Docket No. 52-010

Subject: **Response to Portion of NRC Request for Additional Information Letter No. 319 Related to ESBWR Design Certification Application - RAI 7.1-139**

RAI Number 7.1-139

Figure 7.4-3. Isolation Condenser System Initiation and Actuation

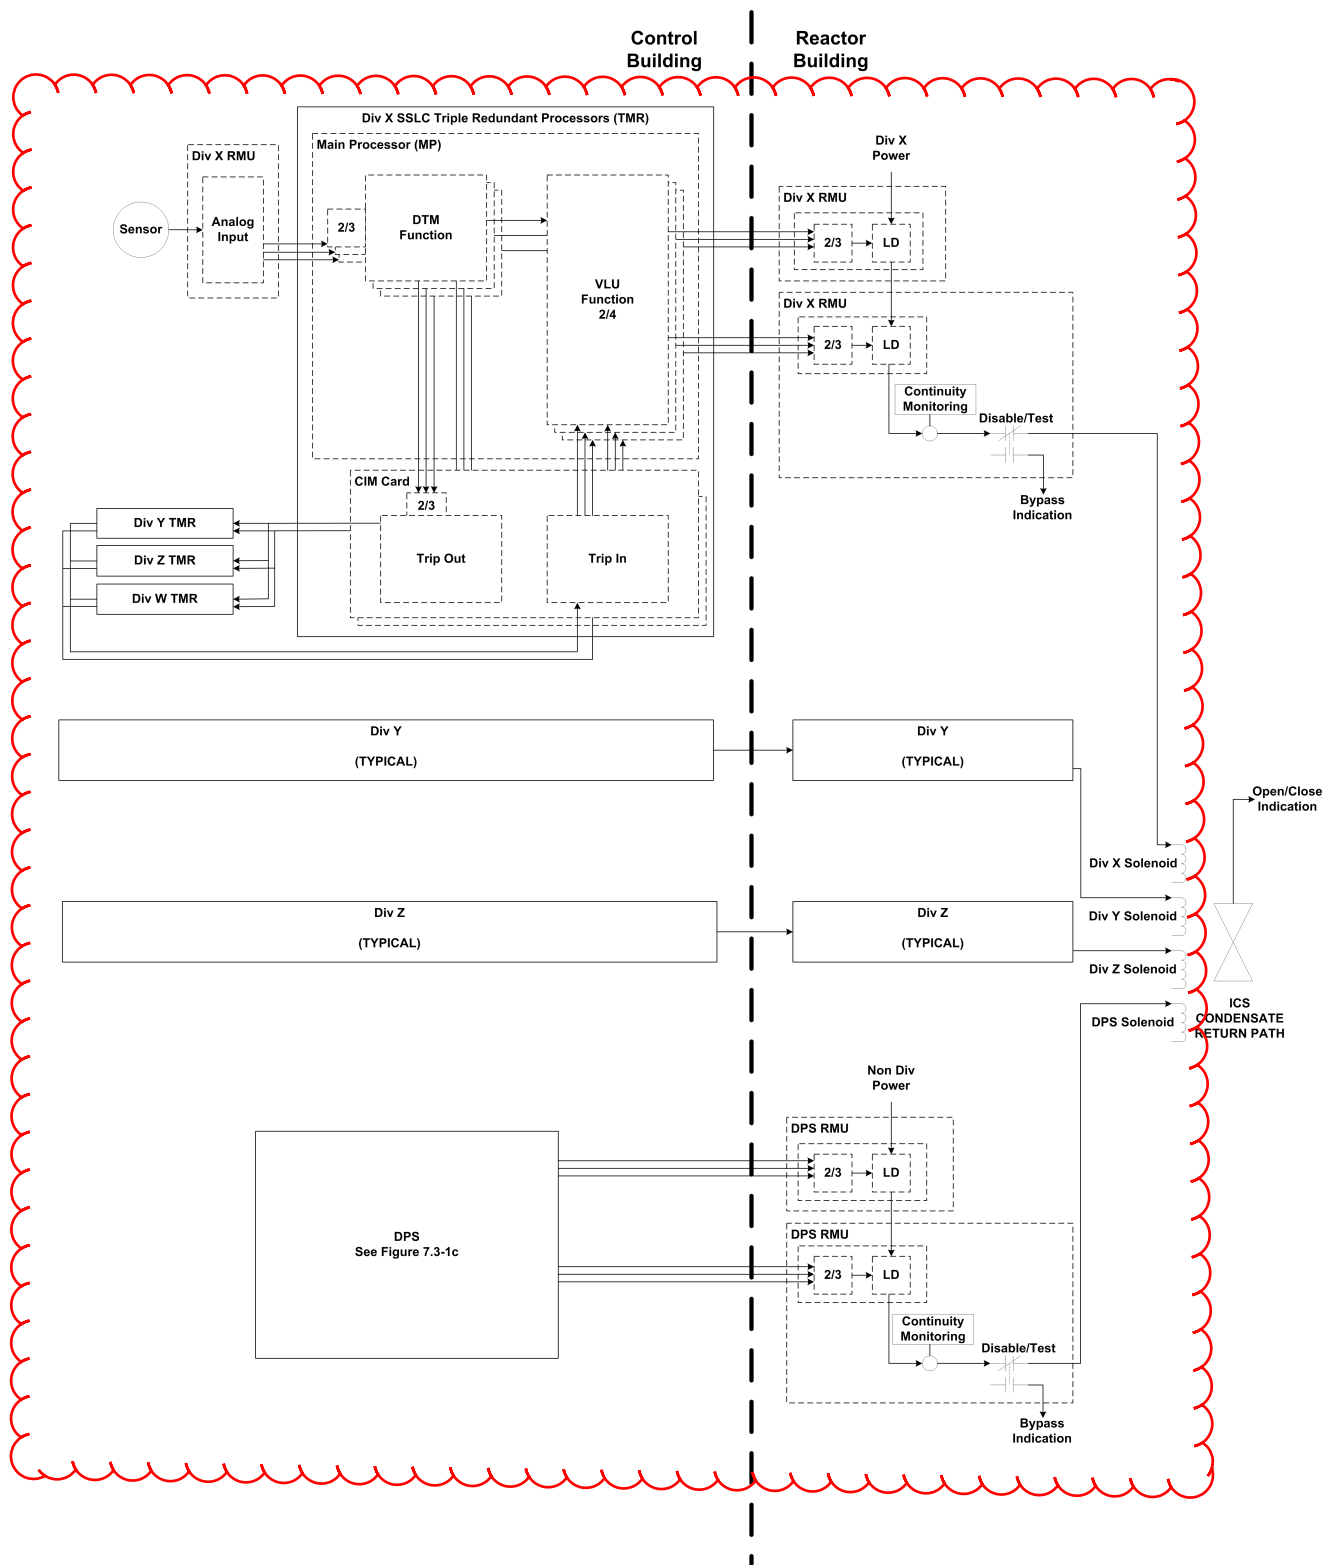
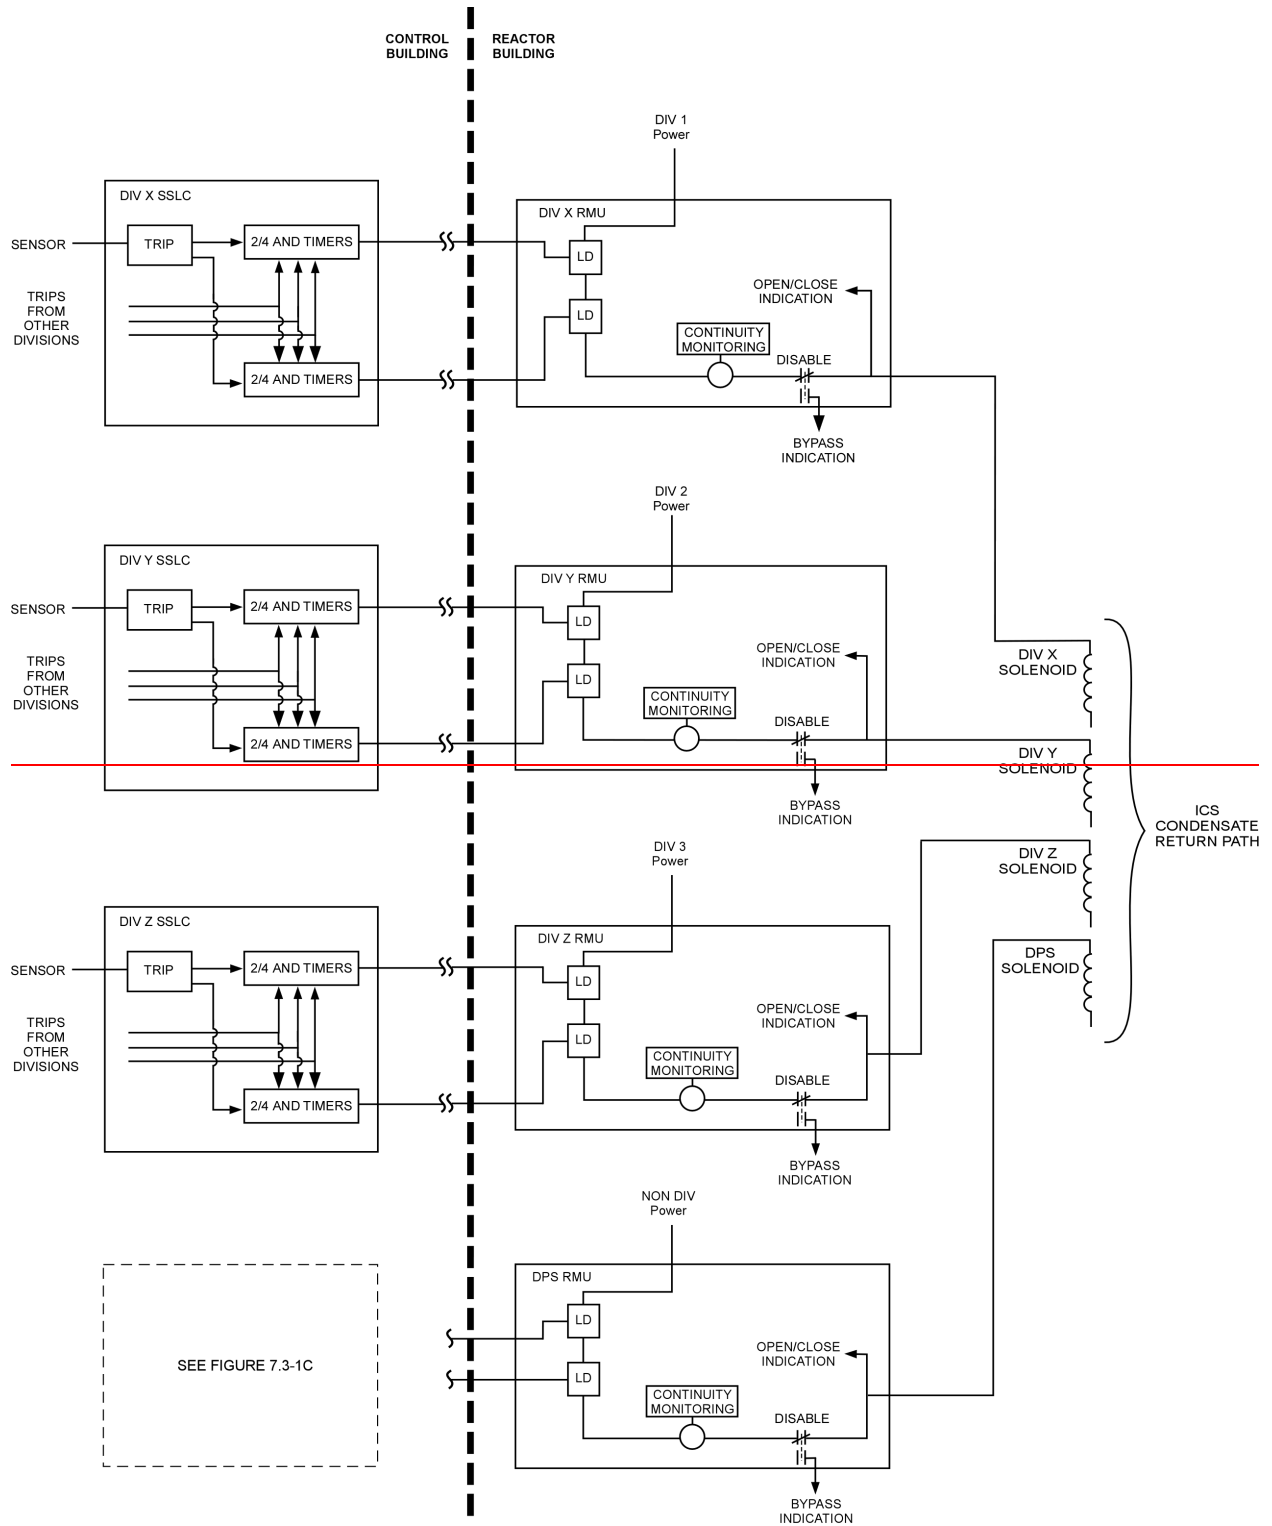
3. *DCD Tier 2 Figure 7.1-1 shows the elements of the Q-DCIS and the N-DCIS with a very high-level functional representation. During the ACRS meeting, GEH presented additional architectural information, including a simplified diagram with a "safety ring." This level of architectural detail needs to be included in the DCD for the safety systems. Add figures with this level of detail to the DCD with corresponding discussion in the text as applicable.*

- Figure 7.4-3, Isolation Condenser System Initiation and Actuation
